ADDENDUM NO. 3

**BREWSTER CENTRAL SCHOOL DISTRICT
BREWSTER HIGH SCHOOL
SECURITY VESTIBULE, SYNTHETIC FIELD AND RELATED WORK**

DATE: May 6, 2024

This Addendum consists of two (2) pages plus Sketches SK-4, SK-5, SK-6, SK-7, SK-8, SK-9, revised specification section 00 4402 Hold Harmless Agreement, specification section 33 4000 Surface Drainage Systems, revised drawing BHS C303 and revised drawing BHS C403.

BHS M102 – EQUIPMENT REPLACEMENT KEYPLAN & PARTIAL PLANS

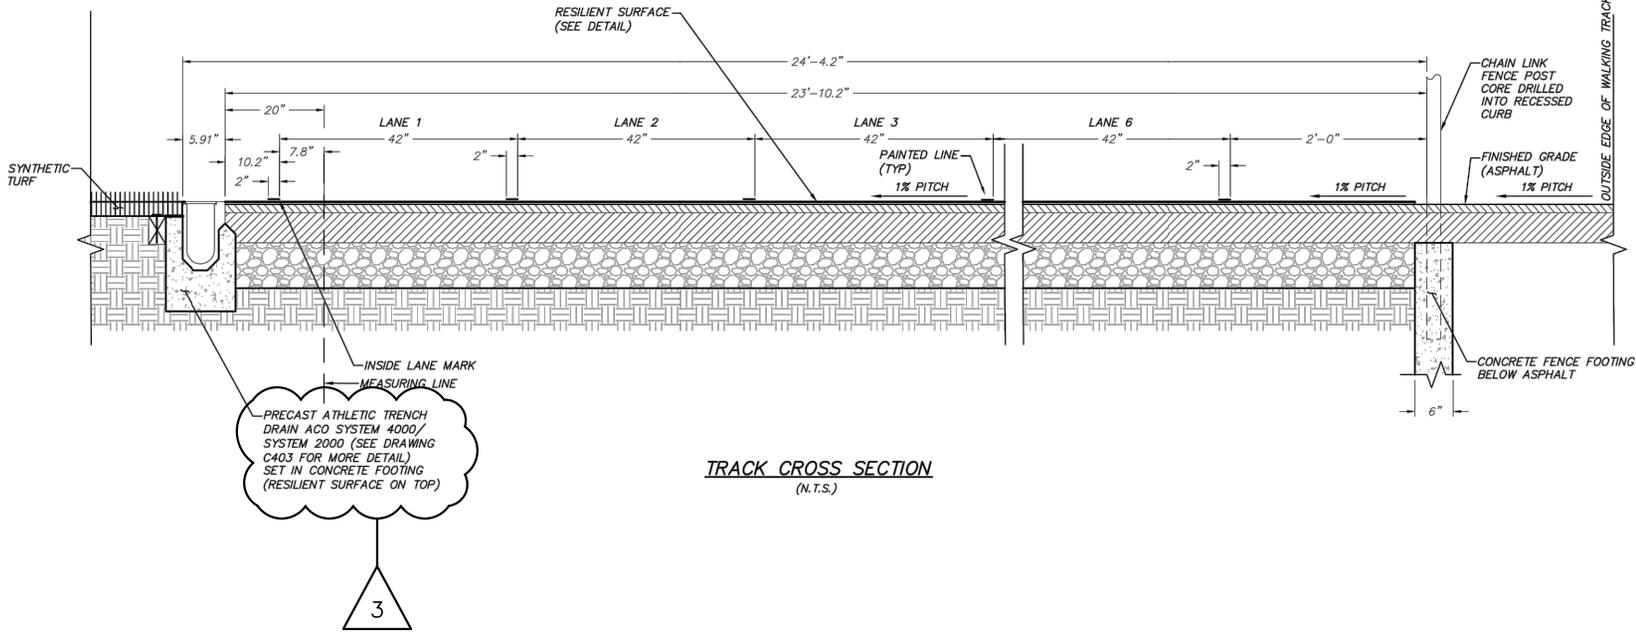
REVISE note “Cutting and Patching of Existing Clg. by Mechanical Contractor” to read “Cutting and Patching of Existing Clg. by General Construction Contractor.”.

TRACK CROSS SECTION
(N.T.S.)

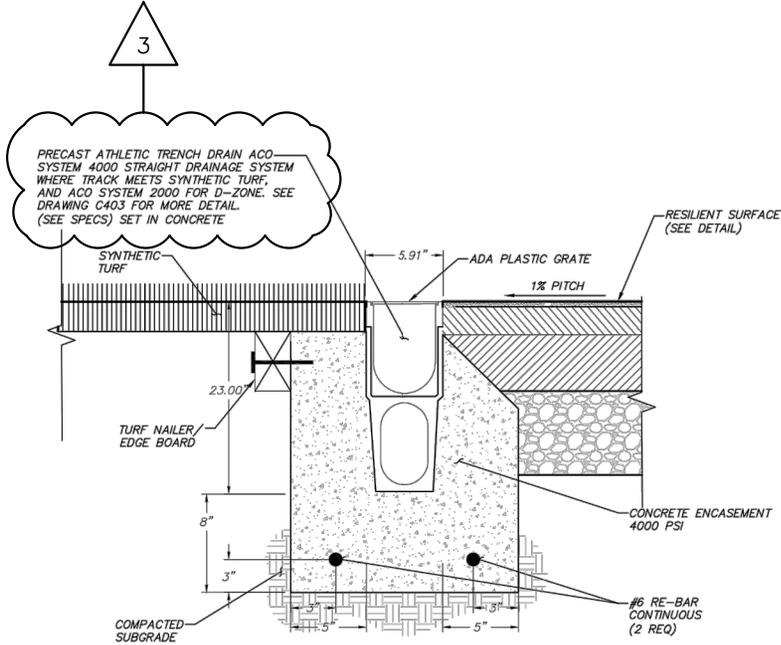
Track Cross Section, **ADD** note as shown on Sketch SK-5 attached to this addendum.
Trench Drain Details, **ADD** note as shown on Sketch SK-6 attached to this addendum.

BSS210 10'H Ball Safety Netting System

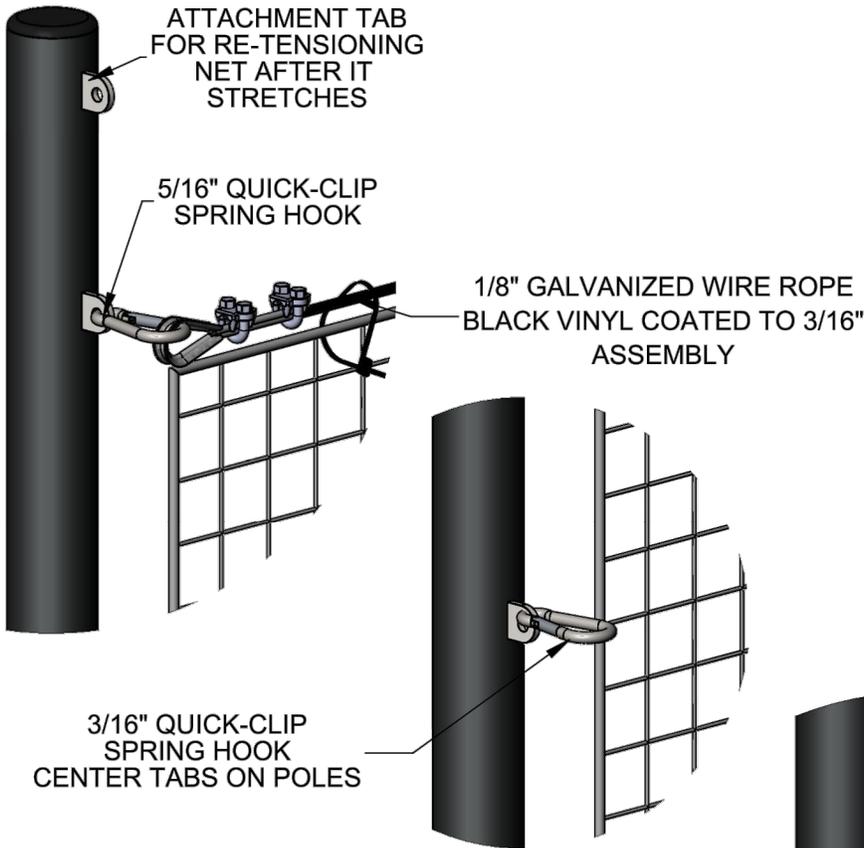
ADD Lacrosse Netting details as shown on Sketches SK-7, SK-8 & SK-9 attached to this addendum.

SHEET SIZE: 30"x42"
 SCALE: 1"=20'
 DRAWING NO: BHS C303
 DRAWN BY: TSM
 FILE NO: 23505.01

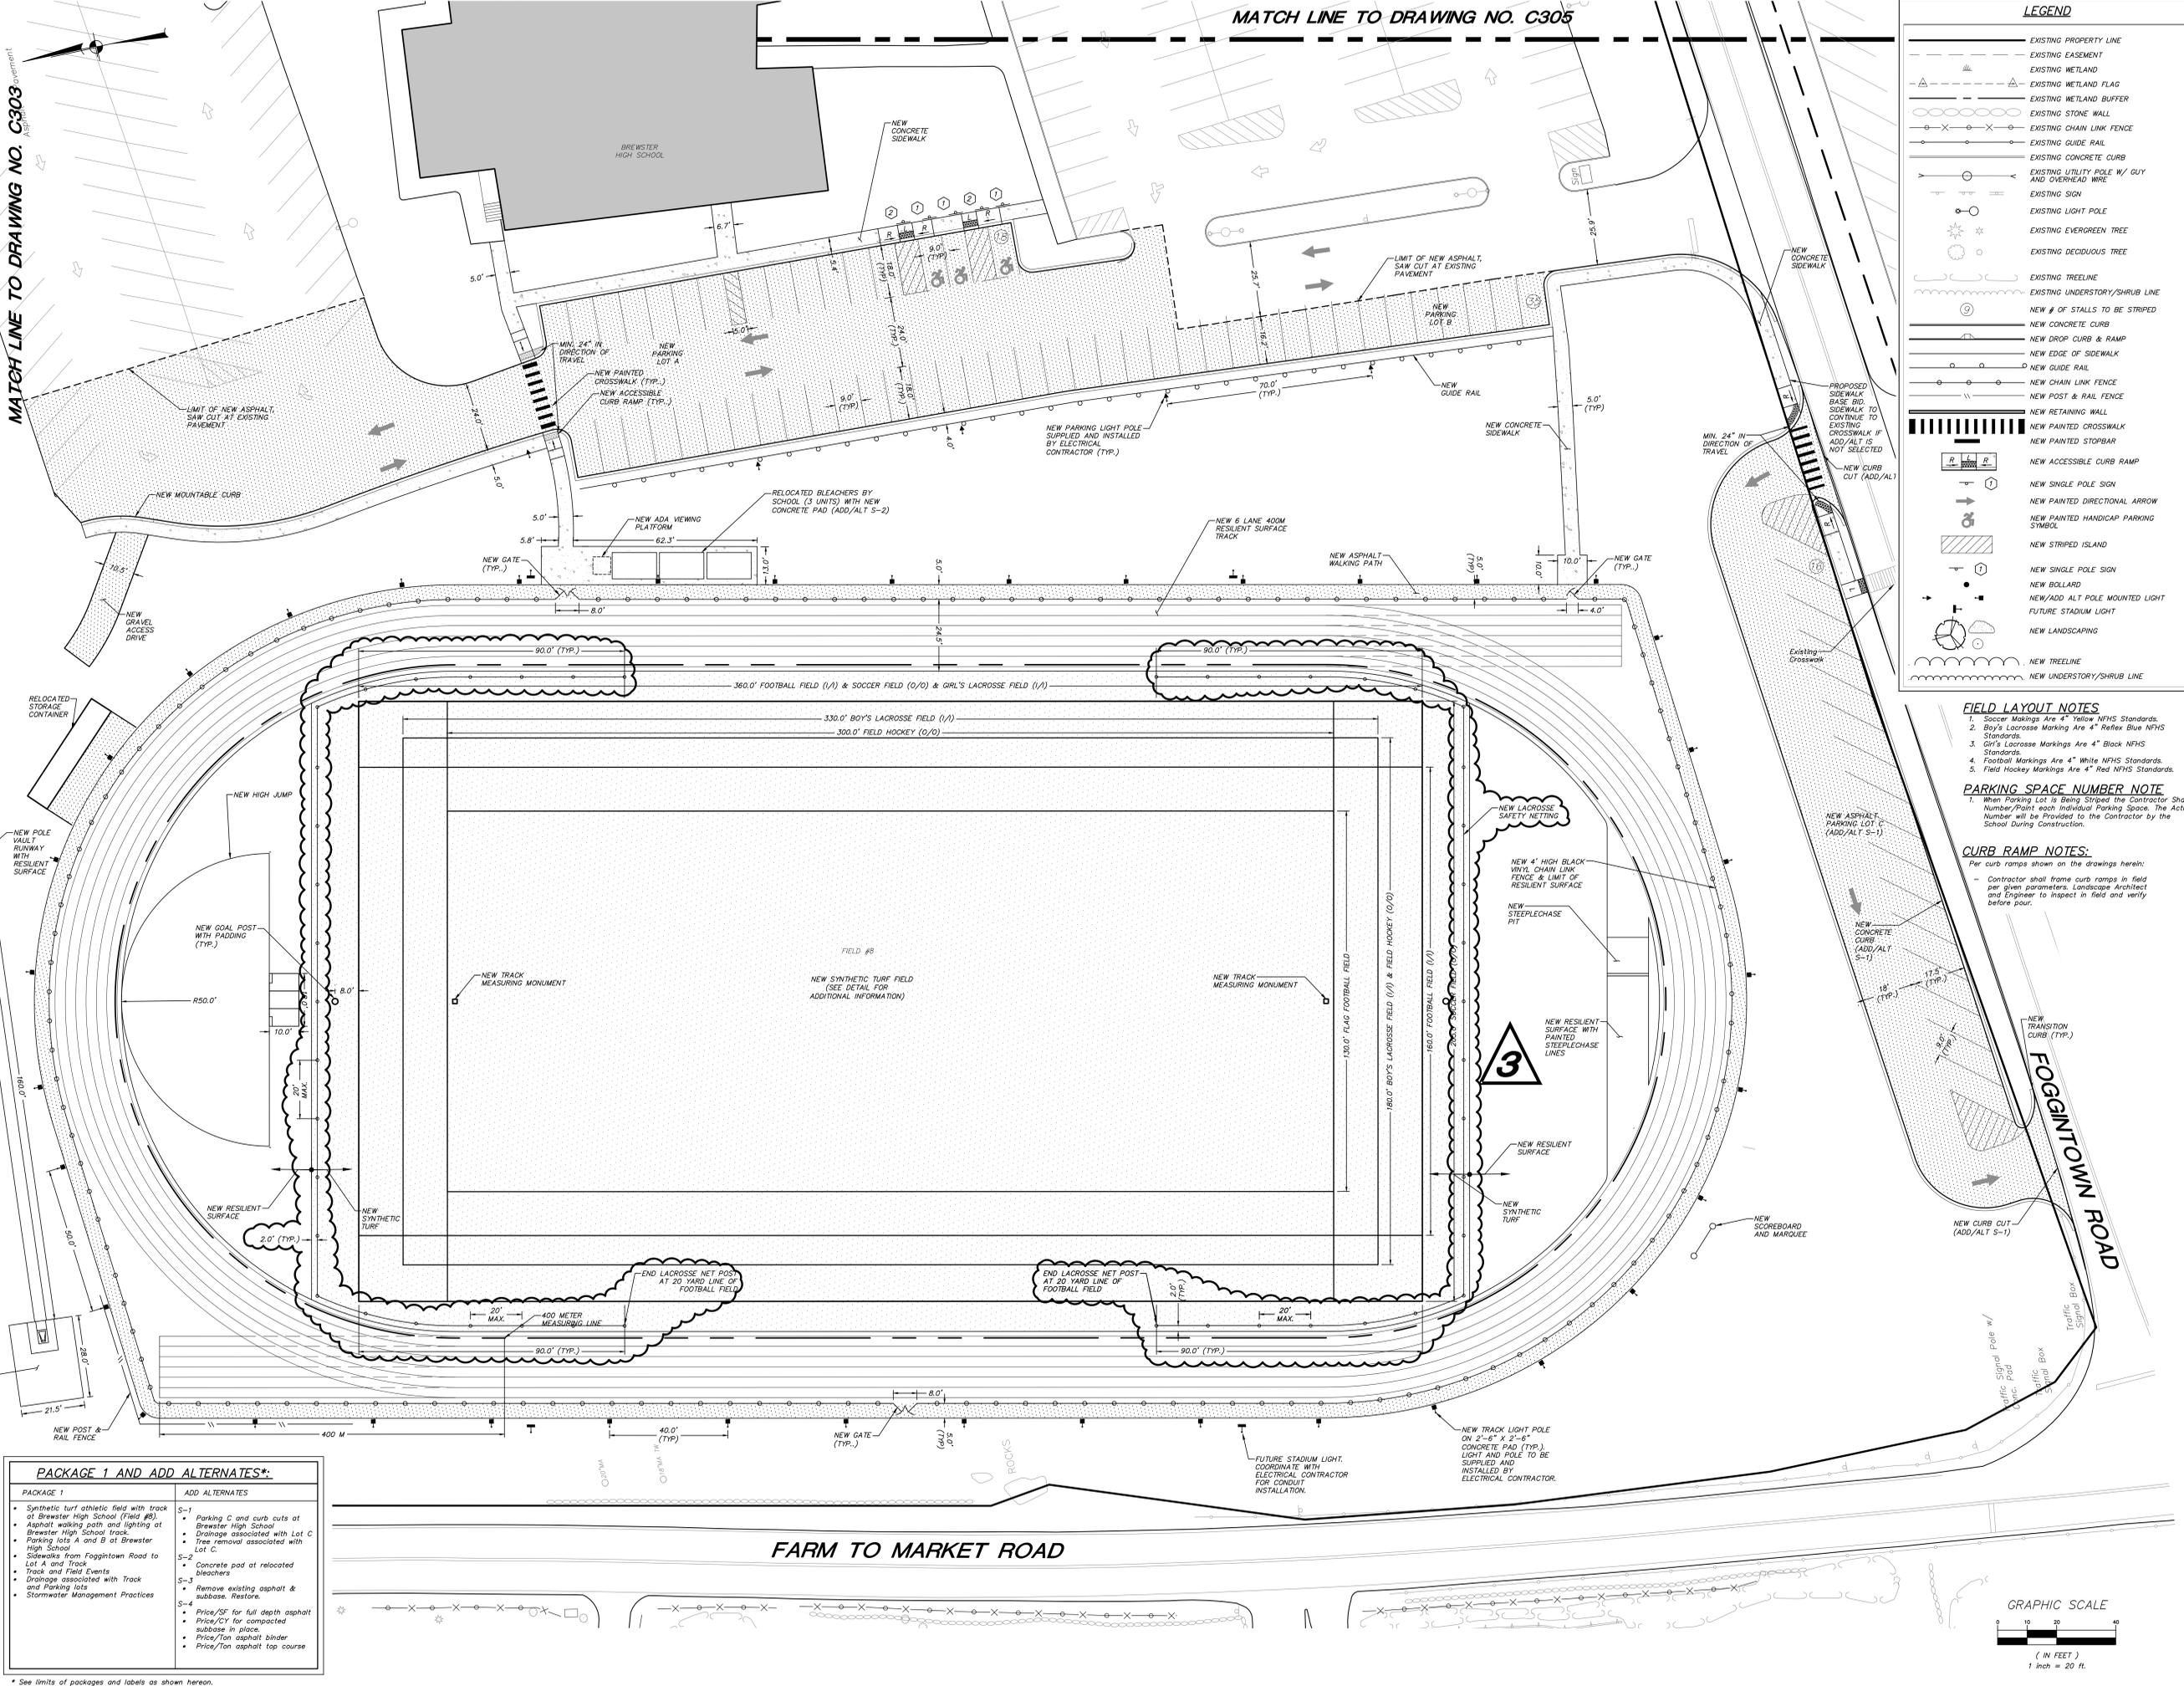
ADD Lacrosse Netting at end zones as shown on revised drawing BHS C303 attached to this addendum.
